**PCN/23/016/C+N-US**

**Product Range:** Han® HPR

**Title:** Change of Han HPR EasyCon Frame

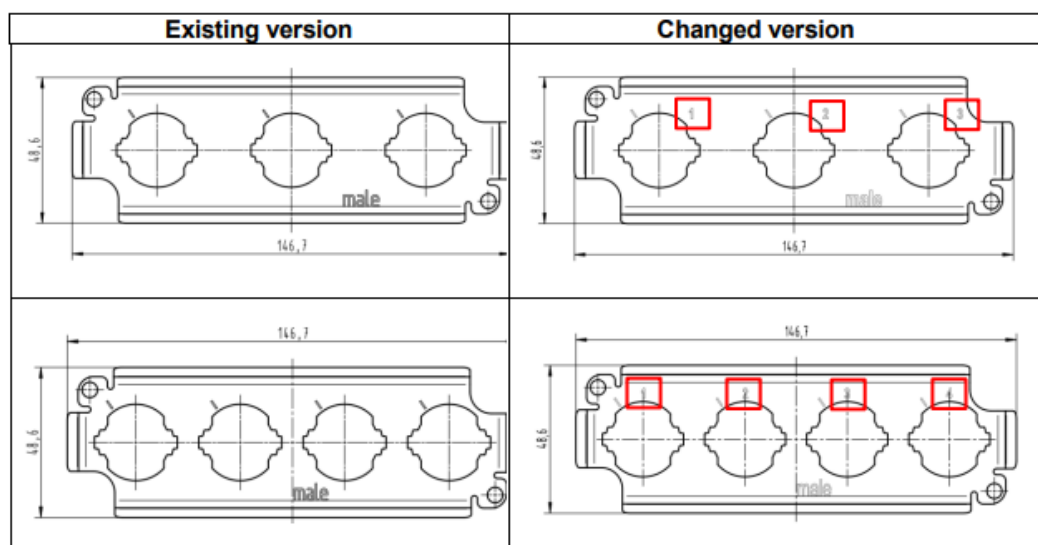
With this change we have added the numbering for the contact position to the Han® HPR EasyCon frames for Han HC-Modular 250.
